APPLICATION NO.	FILING DATE	FIRST NAMED INVENTOR	ATTORNEY DOCKET NO.	CONFIRMATION NO.
10/812,960	03/31/2004	Chih-Kang Wu	SUND 512	4884
23995	7590	12/14/2005	EXAMINER	
RABIN & Berdo, PC 1101 14TH STREET, NW SUITE 500 WASHINGTON, DC 20005			HAN, JASON	
			ART UNIT	PAPER NUMBER
			2875

Office Action Summary	Application No. 10/812,960	Applicant(s) WU, CHIH-KANG	
	Examiner Jason M. Han	Art Unit 2875

DETAILED ACTION

FIG. 1

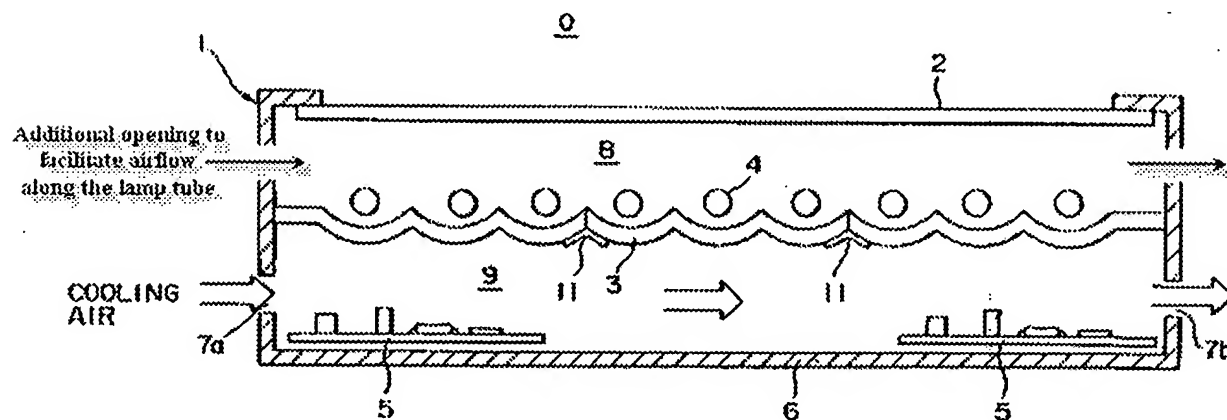
Yamamoto does not specifically teach the two opposite side regions [Figures 1-3: (7a, 7b)] having two opposite openings located at two ends of each side region separately.

However, it would have been obvious to one having ordinary skill in the art at the time the invention was made to incorporate two opposite openings located at two ends of each side region separately, since it has been held that mere duplication of the essential working parts of a device involves only routine skill in the art. *St. Regis Paper Co. v. Bemis Co.*, 193 USPQ 8. In this case, providing additional openings would only facilitate heat transfer within the system, especially with airflow along the lamp as shown in the drawing below.

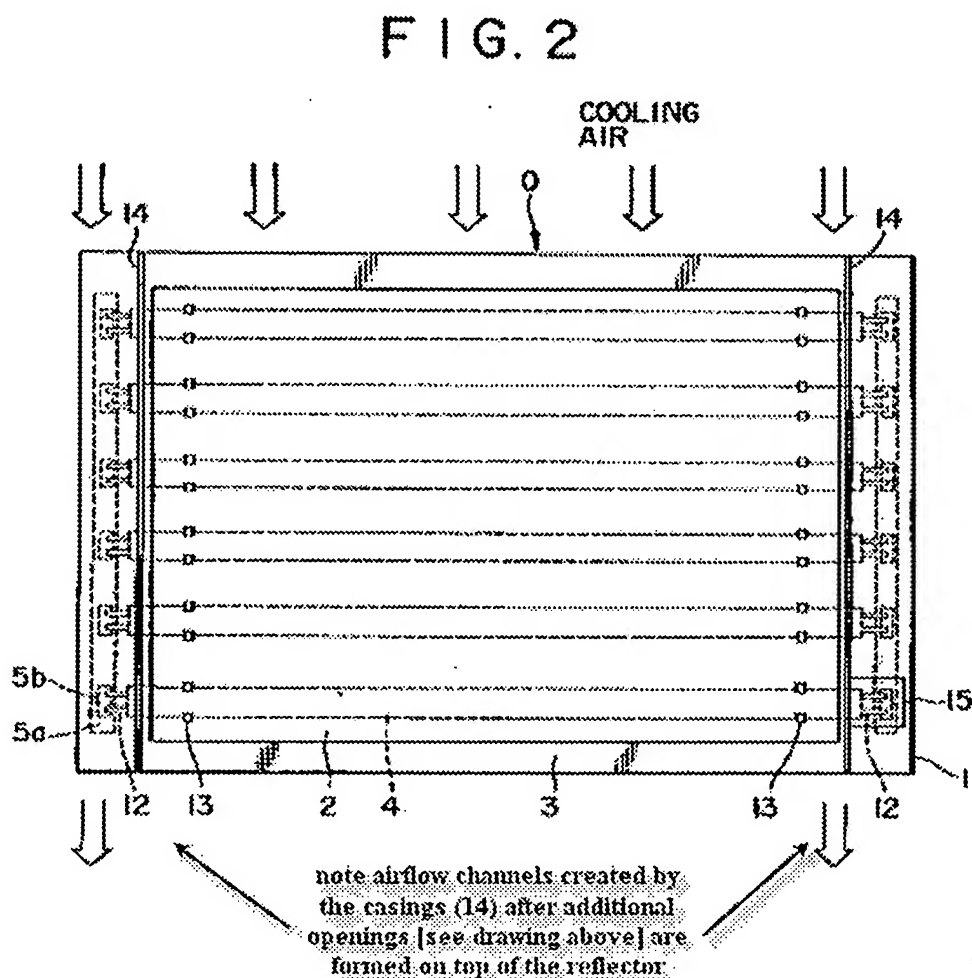
7. With regards to Claim 2, Yamamoto discloses the claimed invention as cited above. In addition, Yamamoto teaches a casing [Figure 2: (14)] for covering the buffer block [Column 4, Lines 23-34], and allowing an airflow channel to be formed by the combination of an inner chamber of the casing and the openings when the casing is installed in the reflective base [see drawing below].

FIG. 1

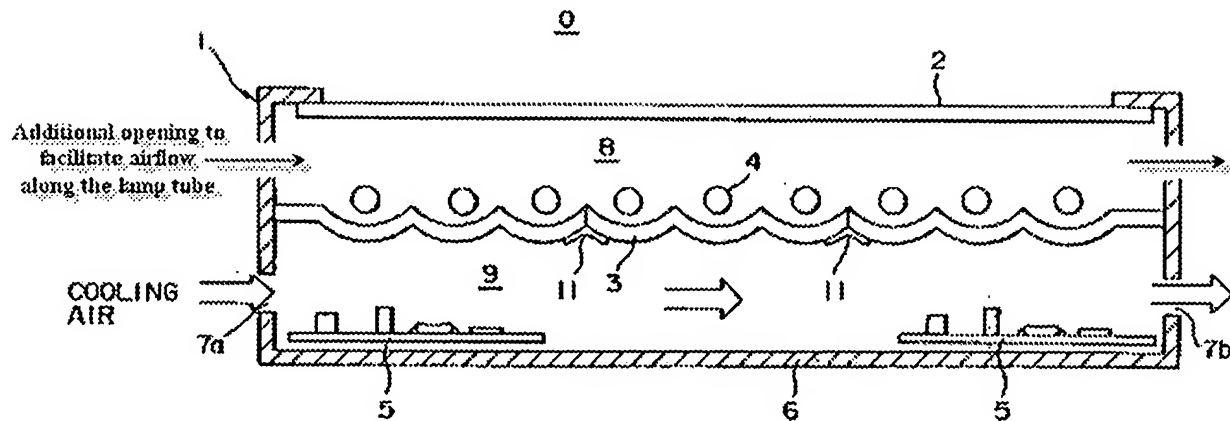
Yamamoto does not specifically teach the two opposite side regions [Figures 1-3: (7a, 7b)] having two opposite openings located at two ends of each side region separately.

However, it would have been obvious to one having ordinary skill in the art at the time the invention was made to incorporate two opposite openings located at two ends of each side region separately, since it has been held that mere duplication of the essential working parts of a device involves only routine skill in the art. *St. Regis Paper Co. v. Bemis Co.*, 193 USPQ 8. In this case, providing additional openings would only facilitate heat transfer within the system, especially with airflow along the lamp as shown in the drawing below.

FIG. 2

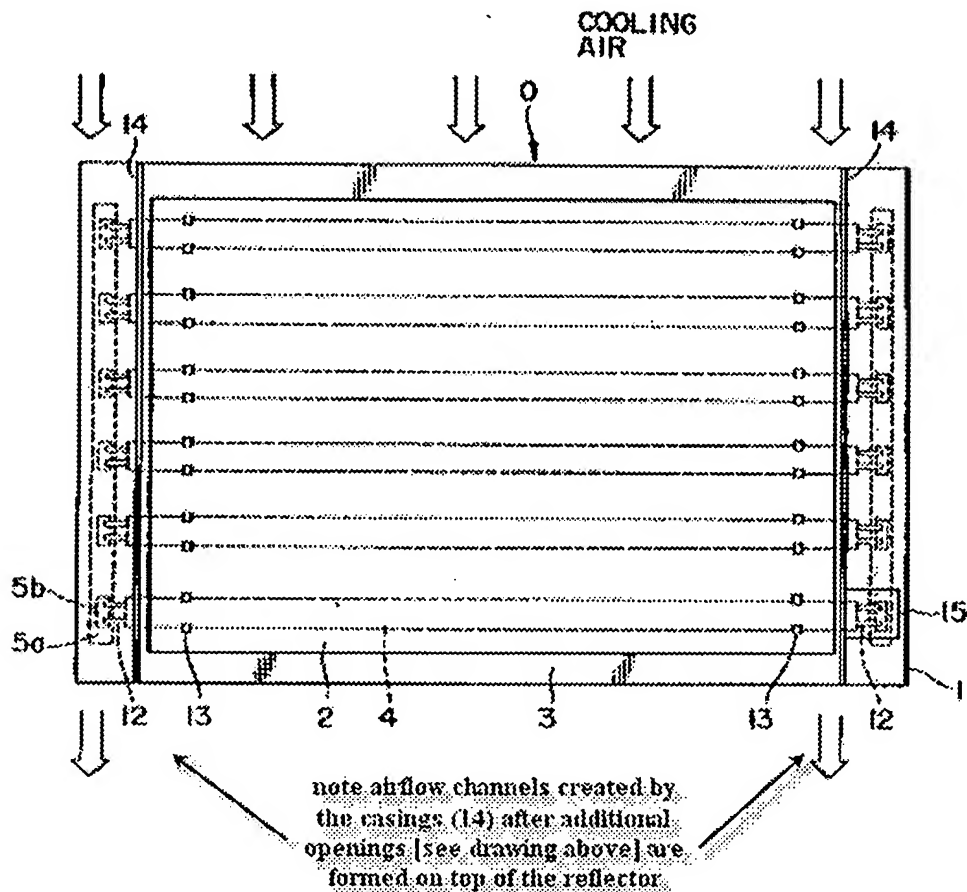
14. With regards to Claim 9, Yamamoto in view of Hayashi discloses the claimed invention as cited above. In addition, Yamamoto teaches a casing [Figure 2: (14)] for covering the buffer block [Column 4, Lines 23-34], and allowing an airflow channel to be formed by the combination of an inner chamber of the casing and the openings when the casing is installed in the reflective base [see drawing below].
